S E R V I C E N O T E

E2500B Frequency Agile Signal Simulator

Potential Servo Failures on 44MB Bernoulli Drives**Parts Required:**

DATE: 15 August 1990

Figure 1. Access Panel Removal

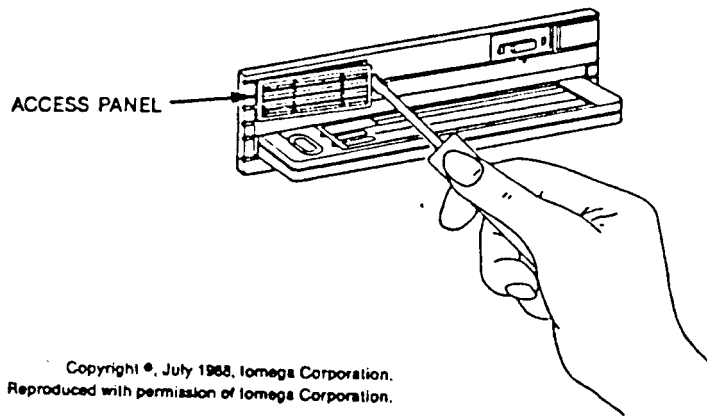
1. Remove Mains from the E2500B FASS by placing the circuit breaker on the system cabinet rear door to the off position.
2. Locate and remove the motor access panel from the front of the 44MB Disk drive assembly by using a small, flat blade screwdriver. See figure 1 for Motor Access Panel location. The manufacturers serial number should be located just inside the motor access area on the flat portion of the front panel. If the manufacturer serial number is one of the above listed serial numbers, use the following procedure to remove the drive from the Smart Interface.

Figure 3. Cover Mounting Screws

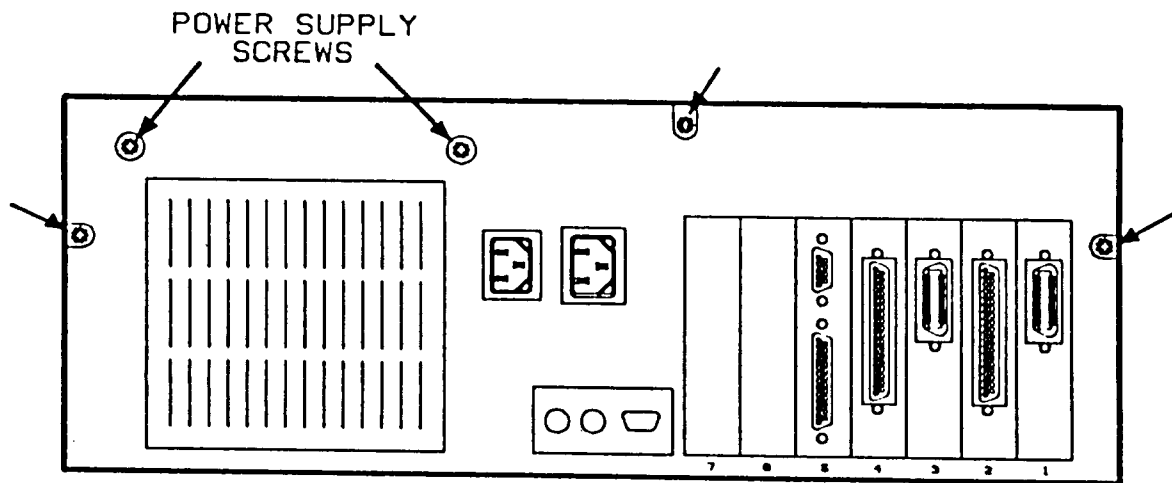
1. Set the Smart Interface (SI) line switch to the off position.
2. Remove the 4 screws at the front of the system cabinet that secure the rack mount to the cabinet.
3. Slide the Smart Interface forward approximately 3 to 4 inches to allow access to the rear of the SI.
4. Open the system cabinet rear door and disconnect the cables that are attached to the Smart Interface rear panel. Refer to figure 2 for system interconnects.
5. Pull the Smart Interface forward until it clears the system cabinet and set it down on an ESD work table.
6. Remove the Smart Interface top cover by removing the 3 screws at the rear of the Smart Interface, remove the top cover by pulling the cover towards the front of the Smart Interface as far as it will go and then lift the cover straight up. See Figure 3 for screw locations.
